INA Service Info

Change to elastic V-ribbed belt

Tensioner pulley 531 0503 10 is no longer needed

Engine: F1AE

Fig. 1: Accessory drive up to Engine No. 0113089 with tensioner pulley

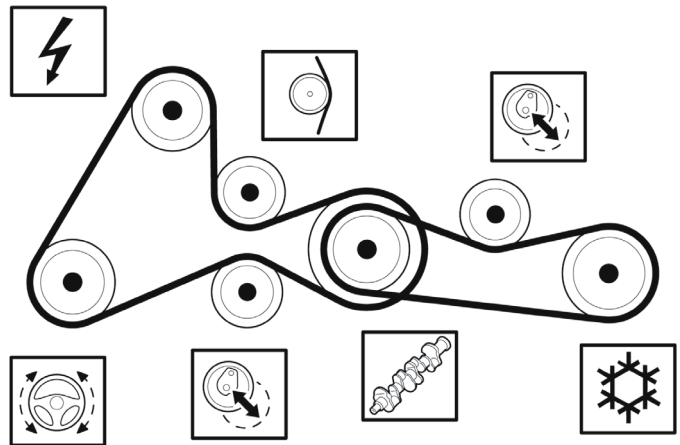
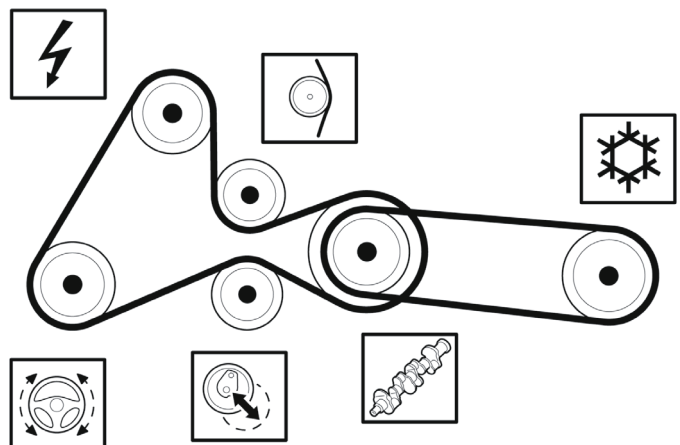
For the accessories drive system of the air conditioning compressor, the manufacturers listed above use an elastic V-ribbed belt starting from Engine No. 0113090. This eliminates the tensioner pulley previously required with the conventional V-ribbed belt.

Engines up to Engine No. 0113089 can also be equipped with the elastic V-ribbed belt FB4EPK903 during preventive maintenance. This, too, eliminates the need for the tensioner pulley.

The elastic V-ribbed belt meets all technical specifications without restriction and can also be safely installed on engines up to Engine No. 0113089. Once an engine has been converted to an elastic V-ribbed belt, a tensioner pulley can no longer be installed under any circumstances.
